PRE-BID MEETING SUMMARY  
LEGISLATIVE HALL HEAT PUMP REPLACEMENT  
OMB/DFM CONTRACT # S MJ1002000007  
ADDENDUM #2

4/11/2013  
 REVISION-ADDENDUM #2

REFERENCE DRAWING: S-201	
SCALE: SEE DRAWING	PROJ NO: 12P223
DRAWN: SDC	SKM-1
DATE: 4/11/2013

**1** TYPICAL NEW WALL SECTION  
 SKM-1 SCALE: N.T.S.

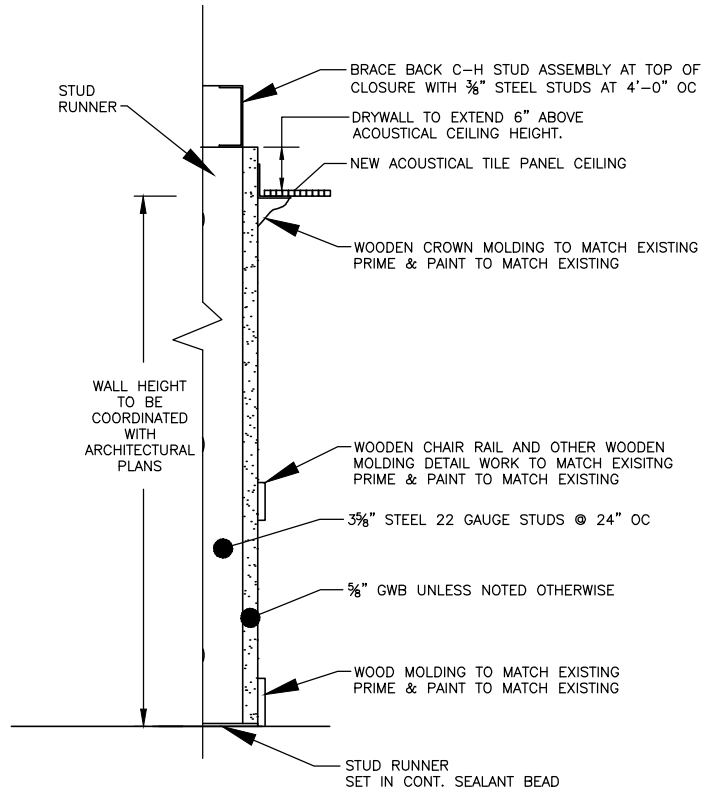
- WALL TYPE:  
 (N) 5/8" GYPSUM WALLBOARD  
 (N) 3/8" STEEL 22 GAUGE STUDS @ 24" OC  
 (N) 5/8" GYPSUM WALLBOARD
